TECHNICAL EVALUATION REPORT

OPERATING REACTOR PORV REPORTS (F-37) TMI ACTION PLAN REQUIREMENTS

GENERIC REPORT -- BABCOCK & WILCOX DESIGNED UNITS

July 20, 1983

Figure 8. (Page 1) Revised Calculation - Davis-Besse

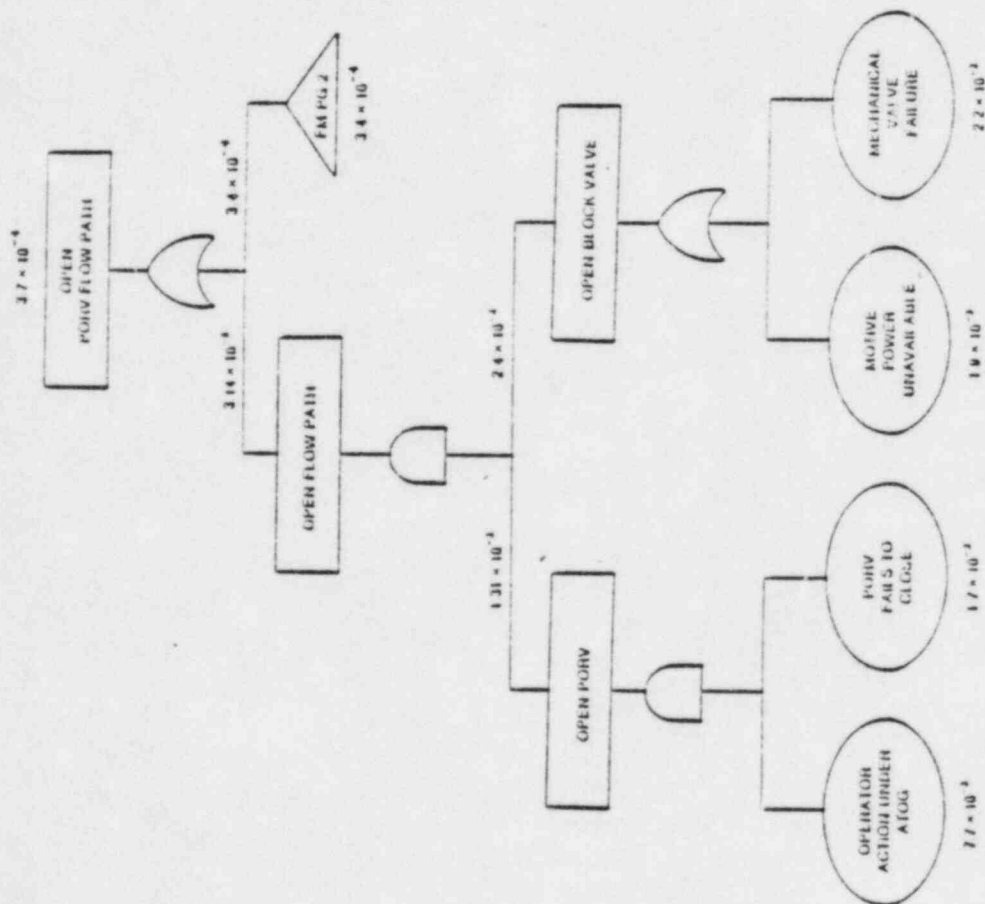
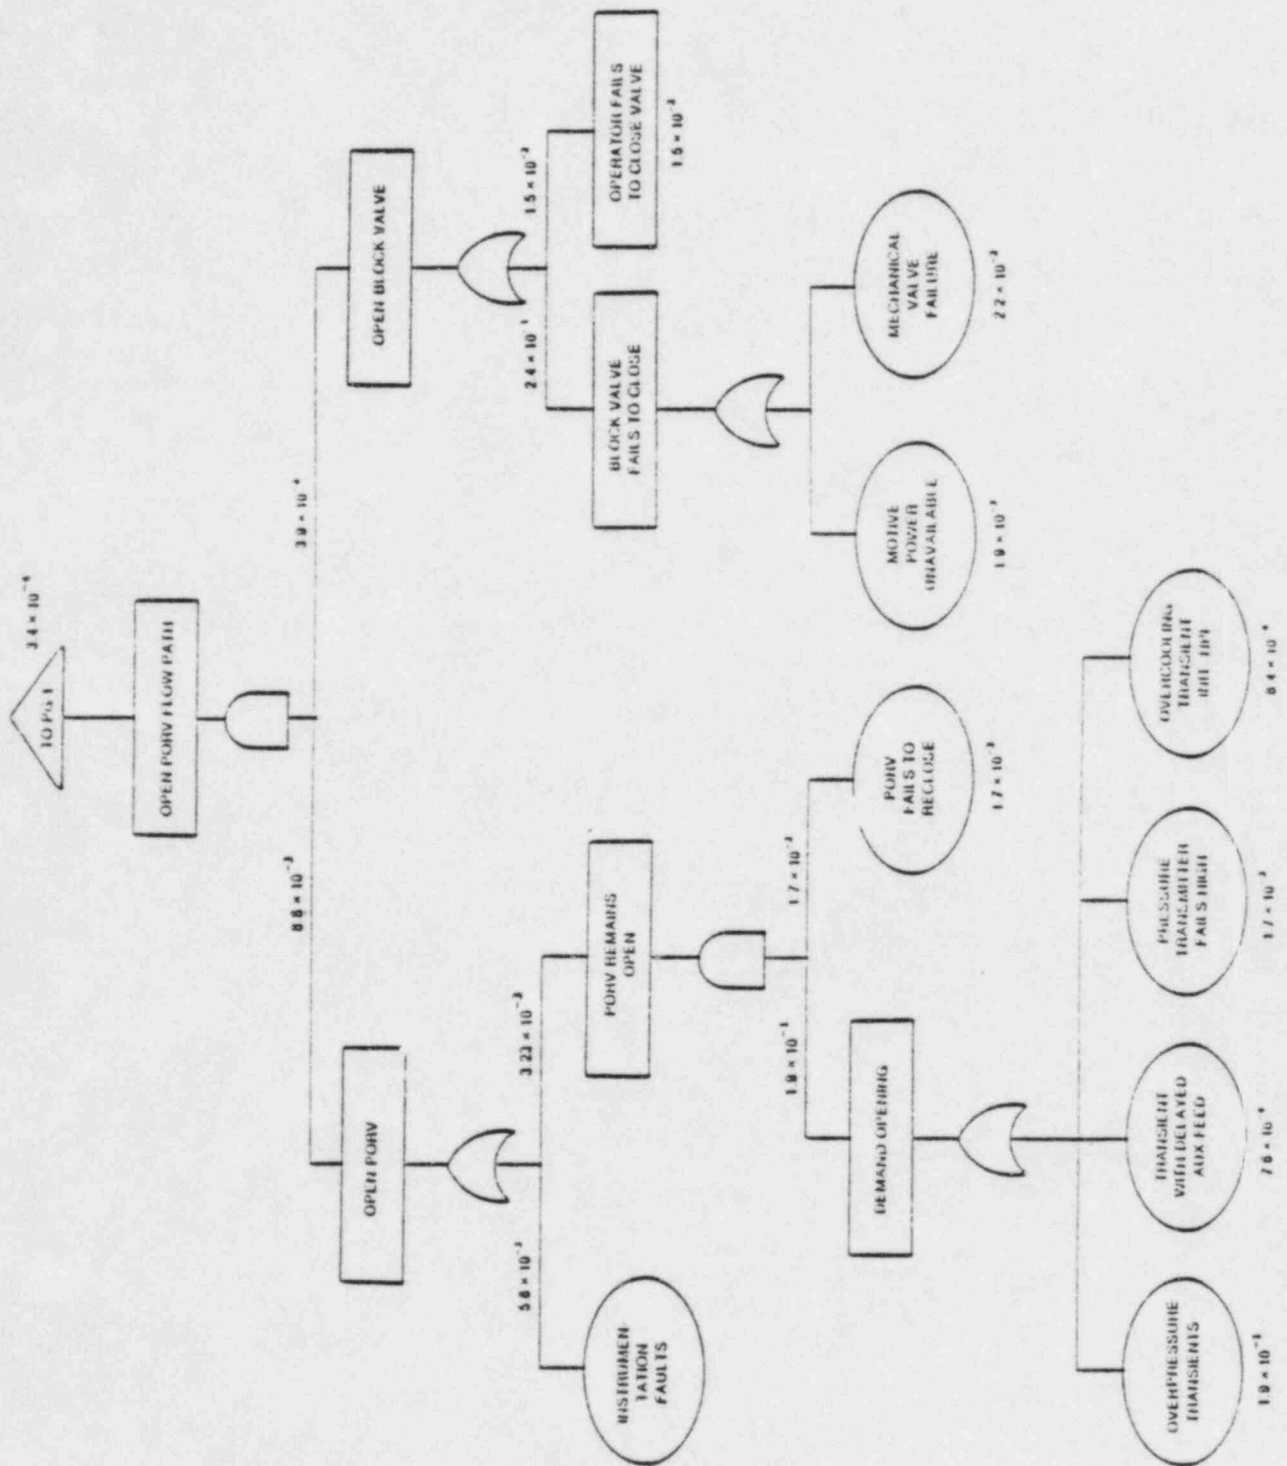
Next, the calculation shown in Figure 2 of this report was repeated for a unit with a PORV setpoint of 2400 psig (e.g., Davis-Besse). In this case, a reactor trip setpoint of 2300 psig with an overshoot of 27 psig and a standard deviation of 27.52 psig was compared with a PORV with a 2400 psig setpoint and a 21.7 psig standard deviation. The analysis showed that the PORV would open with a frequency of 1.9×10^{-2} per event, given an overpressure transient causing a reactor trip. This value was then inserted into Figure 2 and the resulting small-break LOCA probability was determined as follows:

As a result of these calculations, it can be concluded that, although the probability of a small-break LOCA from a stuck-open PORV at the Davis-Besse plant is greater than the same probability at the other B&W units, the difference is not significant and is probably less than a factor of 2 larger. Furthermore, since all values determined are less than the median WA&H-1400 value for small-break LOCA from all causes of 1×10^{-3} per reactor-year, the B&W report can be considered applicable to all B&W units, whether the PORV setpoint is 2450 psig or 2400 psig.
